SUBDIVISION REPORT - CONCEPT/USE ON REVIEW

▶ **FILE #:** 7-SC-20-C **AGENDA ITEM #:** 17
7-C-20-UR **AGENDA DATE:** 9/10/2020

▶ **SUBDIVISION:** SMITH DEVELOPMENT - GOVERNOR JOHN SEVIER HWY.

▶ **PROPOSED USE:** Detached residential subdivision

CONCEPT/DEVELOPMENT PLAN FOR
 SMITH DEVELOPMENT - GOV. JOHN SEVER HIGHWAY
 TAX MAP 148, PARCELS 1 & 1.01
 DISTRICT 9, KNOX COUNTY, TENNESSEE

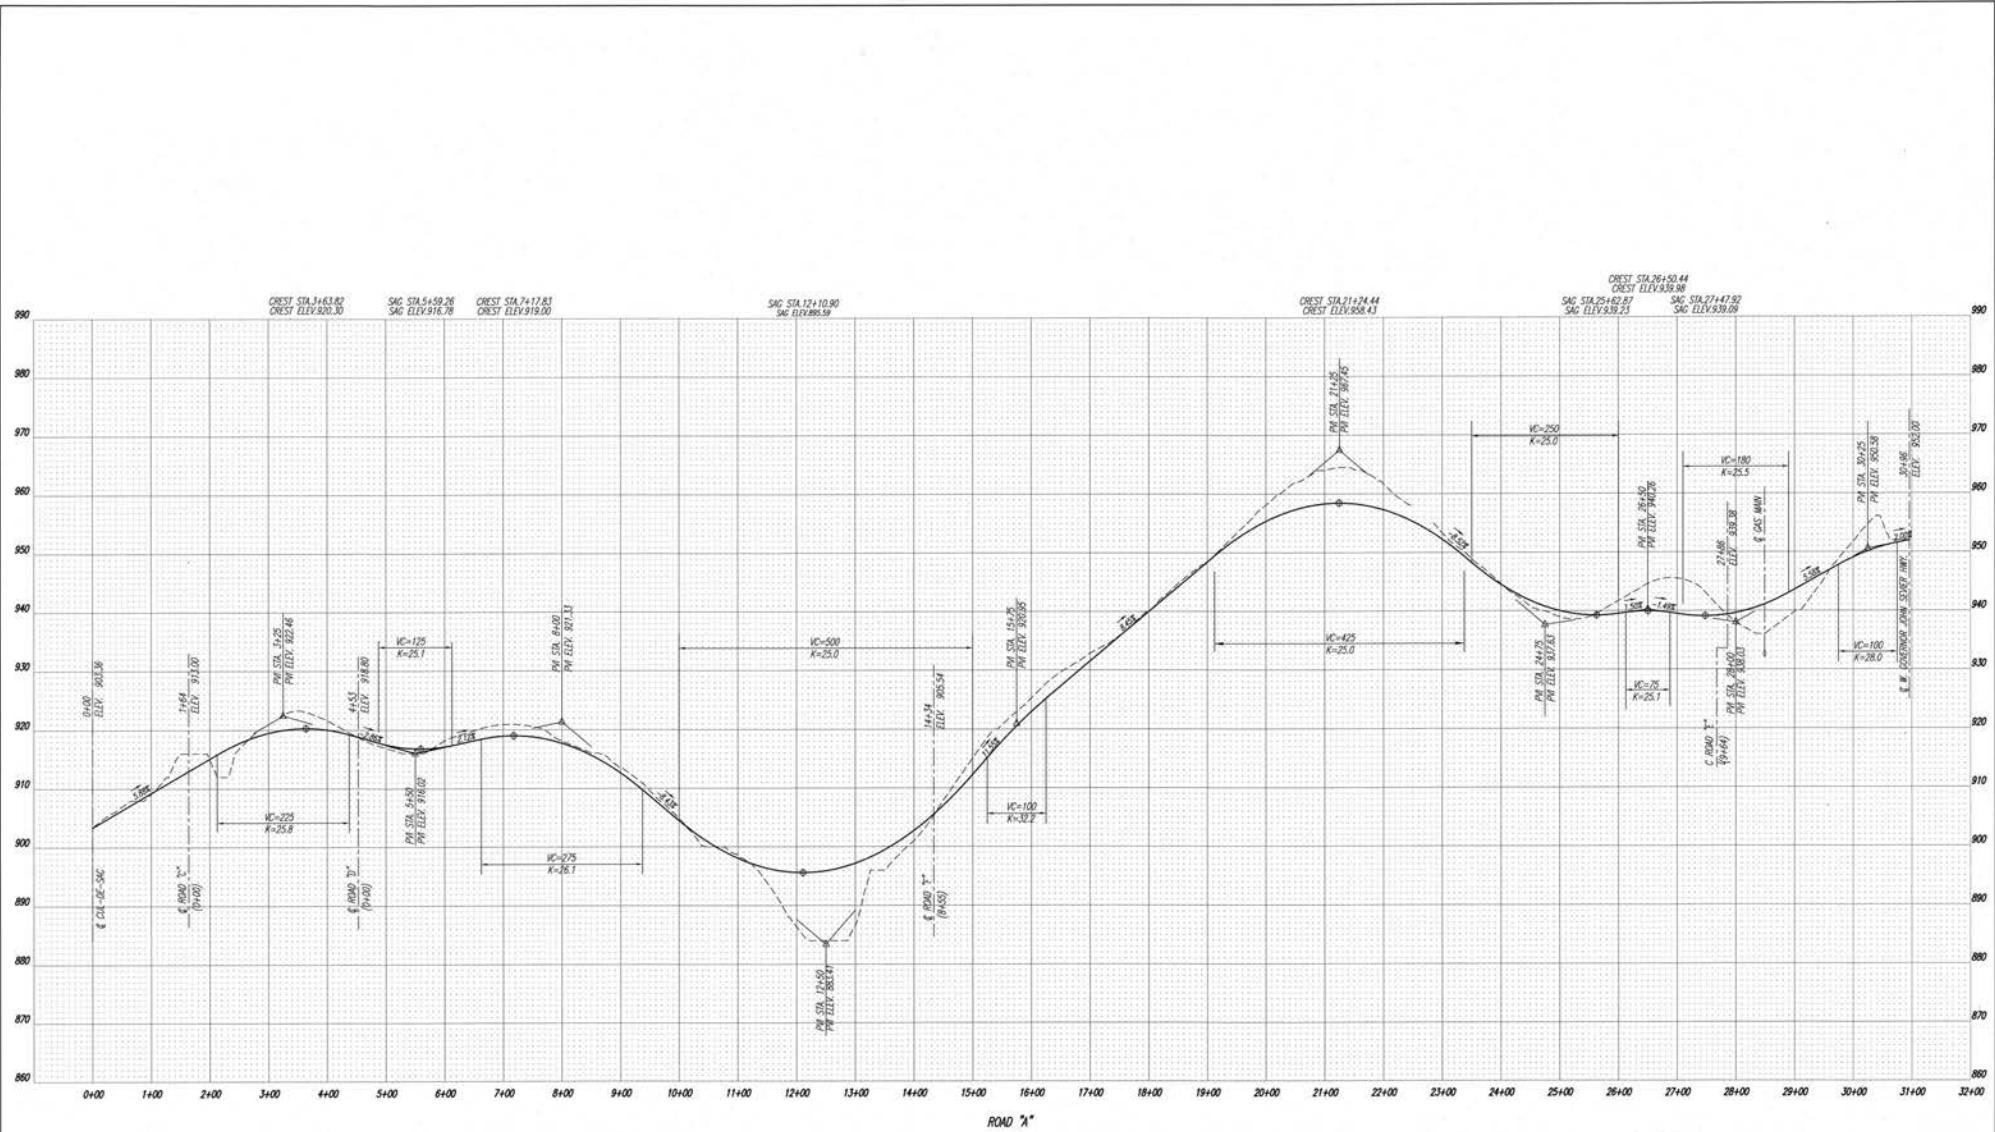
- 1) Reduction of horizontal curve radius on Road 'A' from 250 feet to 125' feet at STA 7+50.
- 2) Reduction of horizontal curve radius on Road 'A' from 250 feet to 175' feet at STA 19+50.
- 3) Reduction of horizontal curve radius on Road 'A' from 250 feet to 175' feet at STA 28+75.

- 1) Intersection grades between 1 and 3 percent for all approaches to an intersection.
- 2) Reduction of the Governor John Sevier Highway right-of-way dedication from 56' to 50'.

- 1) Connection to sanitary sewer and meeting any other relevant requirements of the utility provider.
 - 2) Provision of street names which are consistent with the Uniform Street Naming and Addressing System within Knox County (County Ord. 91-1-102).

- 3) Meeting all applicable requirements of Knox County Engineering and Public Works.
 - 4) Providing a stream determination to Knox County Engineering and Public Works that documents that the blue line stream shown on the USGS maps is not a stream. If it is determined to be a stream, the appropriate buffers must be provided. The location of the blue line is in the general location of Road 'E' and crosses under Governor John Sevier Highway at the northwest corner of the site.

- 6) Providing a 200' sight distance easement along the Road 'A' frontage of Lot 89 as identified on the Concept Plan.
 - 7) Providing documentation of an approved waiver from the Tennessee Department of Transportation (TDOT) during design plan review for the requested reduction of right-of-way dedication from 56' to 50' from the centerline of Governor John Sevier Highway. If TDOT does not approve the waiver, the right-of-way requirements of the Major Road Plan must be dedicated.

- 2) Providing a tree buffer with 50' of depth along the Governor John Sevier Highway frontage this is within common area, as shown on the development plan.

- 3) Installation of fencing to protect the trees identified as within the 50-foot tree buffer/common area along Governor John Sevier Highway. This fencing is to be installed before grading activities begin on the site.

- 4) Providing a note on the final plat stating, "No trees in the 50-foot 'tree buffer' shall be removed unless it is dead or dying, an invasive species, or must be removed for safety reasons, such as sight distance standards or the tree presents a falling hazard."

- **APPROVE** alternate design standard 1-3 based on the recommendations of the Knox County Department of Engineering and Public Works.

APPROVE the Concept Plan subject to 8 conditions.

TABLE 6
2025 INTERSECTION CAPACITY ANALYSIS RESULTS -
WEST GOVERNOR JOHN SEVIER HIGHWAY (SR 168) AT ROAD "A"
OPENING YEAR (WITH PROJECT) AND EB RIGHT TURN LANE

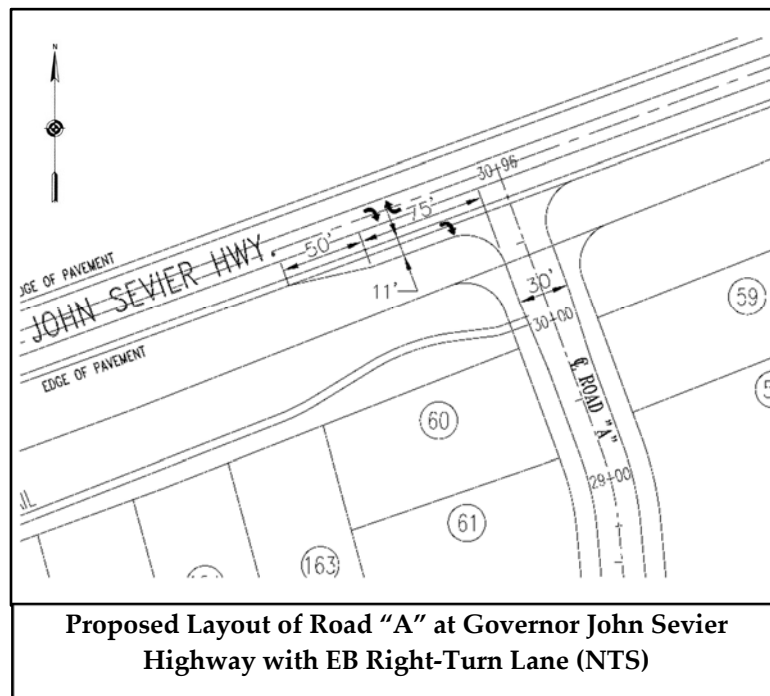
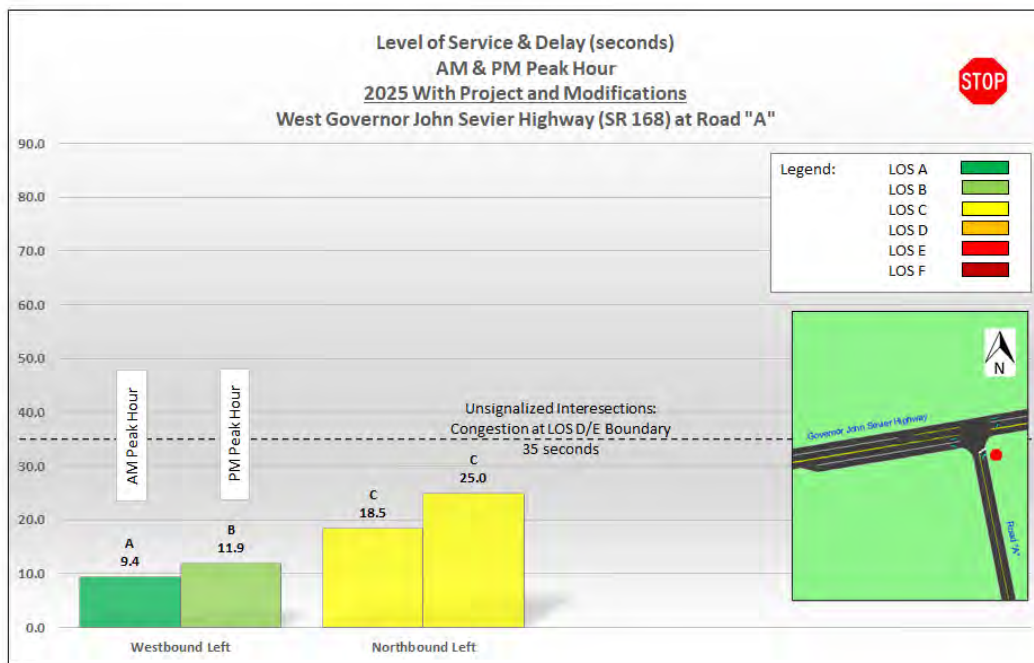
- 1c) As discussed earlier in Potential Safety Issues, Evaluation of Turn Lane Thresholds, the intersection of West Governor John Sevier Highway (SR 168) at Road "A" does not warrant an exclusive eastbound right-turn lane. However, after reviewing this study, the TDOT has recommended that a separate right-turn lane be constructed at Road "A". Typically, the length of a right-turn lane would be determined by calculating the stopping sight distance based on the observed operating speed. The length recommended in A Policy on Geometric Design of Highway and Streets by AASHTO is calculated to be 480 feet for eastbound vehicles to decelerate and stop from an observed 85th percentile speed of 55.7 mph. However, this recommended length is based on vehicles coming to a complete stop, and the right-turning vehicles coming off West Governor John Sevier Highway (SR 168) onto Road "A" will not completely stop. The civil site designer has proposed for a 75-foot right-turn storage length with a 50-foot taper. A diagram of this layout at Road "A" is provided below. The right-turn lane should be marked with the appropriate right-turn pavement marking symbols. With the recommended right-turn eastbound lane at Road "A", the capacity analysis was re-calculated, and the results are shown in Table 6.

1d) Sight distance at the new proposed Road “A” at West Governor John Sevier Highway (SR 168) intersection must not be impacted by new signage, future landscaping, or existing vegetation. The existing site is heavily forested and will need site clearing along the highway to ensure sight distances are adequate. Based on the highest observed and calculated 85th percentile speed of 55.7 mph on West Governor John Sevier Highway (SR 168), the required Intersection Sight Distance (ISD) is 655 feet and the Stopping Sight Distance (SSD) is 530 feet for westbound vehicles and 480 feet for eastbound vehicles. This should be verified in the design plans.

- 1e) It is recommended that the Road "A" entrance approach at West Governor John Sevier Highway (SR 168) be designed and constructed with a 24" white stop bar and a Stop Sign (R1-1). The continuous center two-way left-turn lane (TWLTL) of West Governor John Sevier Highway (SR 168) should be re-striped to accommodate the new intersection with the new turning movements. This would involve installing breaks in the striping in the existing continuous center two-way left-turn lane (TWLTL).

- 1f) After reviewing this study, TDOT and Knox County has recommended that the entrance for Road "A" be designed with a wider width of 30 feet to accommodate larger vehicles.

TABLE 7
 2025 INTERSECTION CAPACITY ANALYSIS RESULTS -
 WEST GOVERNOR JOHN SEVIER HIGHWAY (SR 168) AT ROAD "B"
 OPENING YEAR (WITH PROJECT) AND EB RIGHT TURN LANE

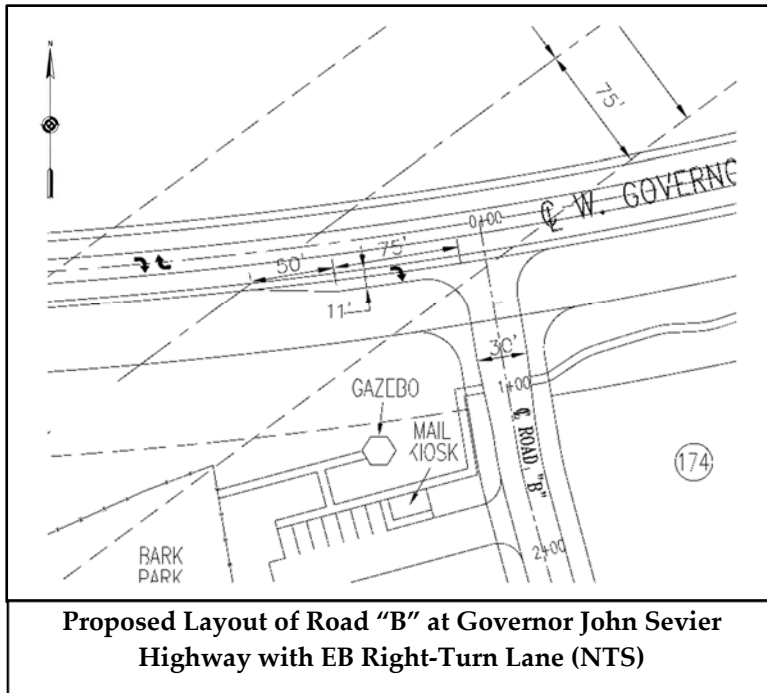
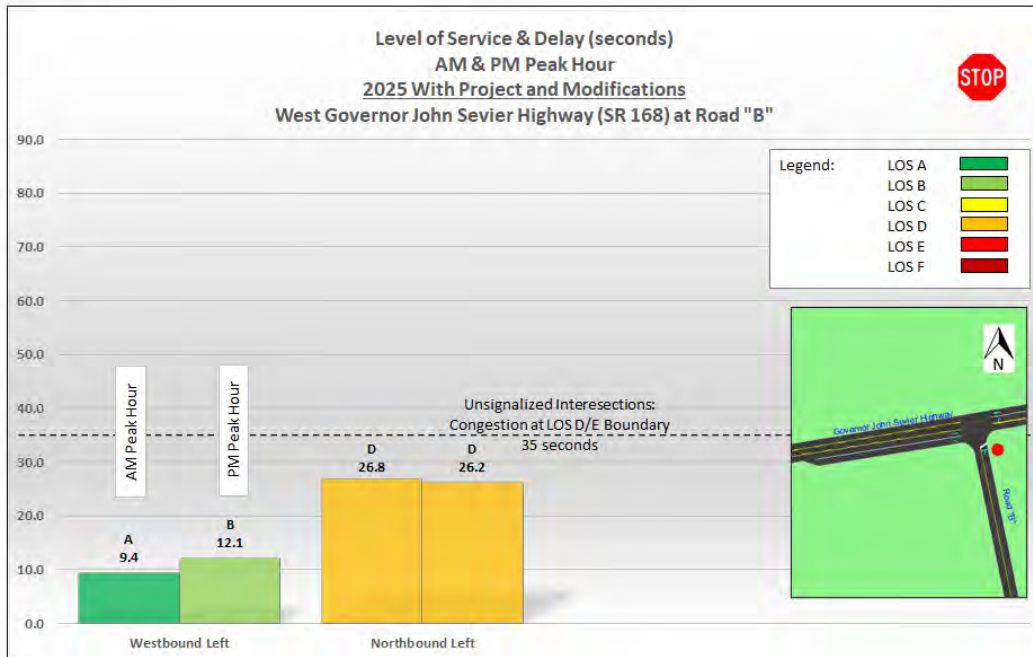
- 2c) As discussed earlier in Potential Safety Issues, Evaluation of Turn Lane Thresholds, the intersection of West Governor John Sevier Highway (SR 168) at Road "B" does warrant an exclusive eastbound right-turn lane. Typically, the length of a right-turn lane would be determined by calculating the stopping sight distance based on the observed operating speed. The length recommended in A Policy on Geometric Design of Highway and Streets by AASHTO is calculated to be 480 feet for eastbound vehicles to decelerate and stop from an observed 85th percentile speed of 55.7 mph. However, this recommended length is based on vehicles coming to a complete stop, and the right-turning vehicles coming off West Governor John Sevier Highway (SR 168) onto Road "B" will not completely stop. The civil site designer has proposed for a 75-foot right-turn storage length with a 50-foot taper. A diagram of this layout at Road "B" is provided below. The right-turn lane should be marked with the appropriate right-turn pavement marking symbols. With the recommended right-turn eastbound lane at Road

“B”, the capacity analysis was re-calculated, and the results are shown in Table 7.

2d) Sight distance at the new proposed Road "B" at West Governor John Sevier Highway (SR 168) intersection must not be impacted by new signage, future landscaping, or existing vegetation. The existing site is heavily forested and will need site clearing along the highway to ensure sight distances are adequate. Based on the highest observed and calculated 85th percentile speed of 55.7 mph on West Governor John Sevier Highway (SR 168), the required Intersection Sight Distance (ISD) is 655 feet and the Stopping Sight Distance (SSD) is 530 feet for westbound vehicles and 480 feet for eastbound vehicles. This should be verified in the design plans.
